From: [REDACTED]
Sent: 2025-10-22 星期三 10:59:46
To: [REDACTED]
Subject: A/YL-PH/1079 排水建議及補充資料
Attachment: A_YL-PH_1079 排水建議.pdf; A_YL-PH_1079 回應渠務署意見.pdf; 補充資料.pdf; 補充資料 2.pdf

規劃編號：A/YL-PH/1079

提議雨水渠務報告 (Proposed)

簡介 回復2025-08-28日信函

Drawing number : b2-1

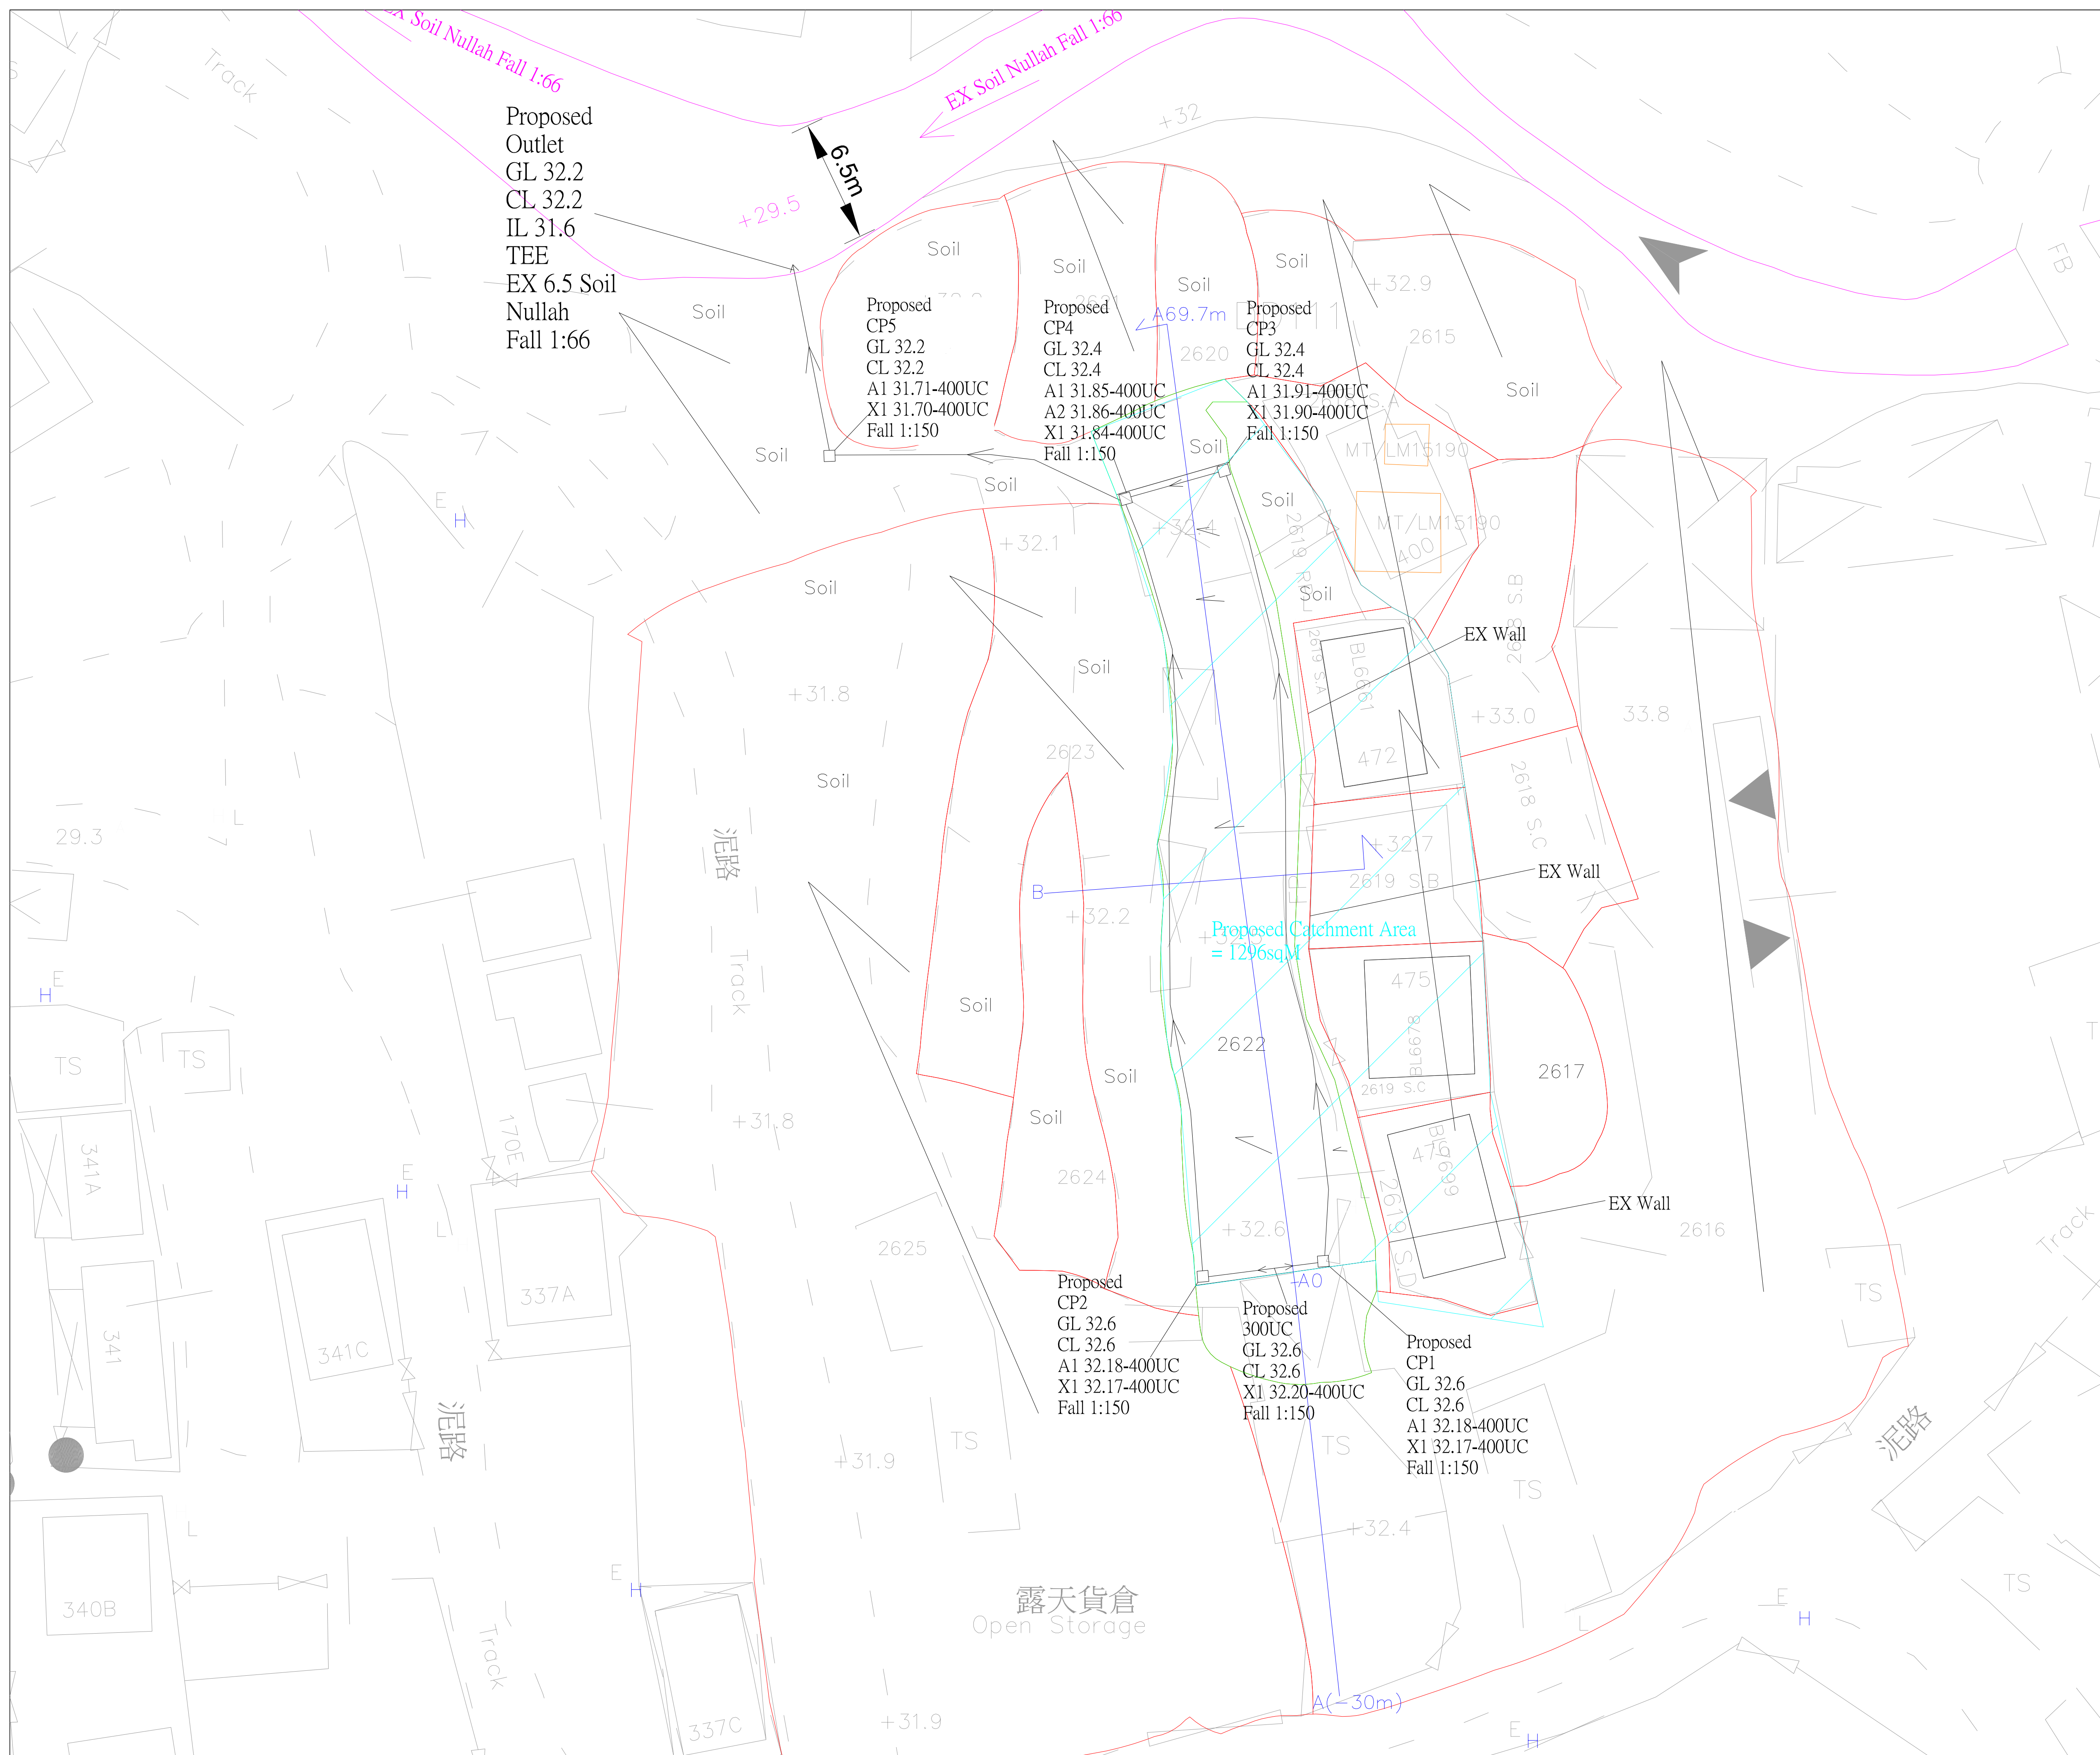
(b) The ground level at the southern side of the application site is higher. The applicant should review the existing site condition, take into account any overflow and review the total catchment area adopted in the drainage design and calculation.	在圖b2-1 中以加大Catchment Area和 改用Proposed 400UC

(e) Cross sections A-A should be extended to show the levels at the southern side of the site, up to the existing road.	在d1-1中示
(f) Please show the discharge point details and the standard details in separate drawings.	在b2-1 中示
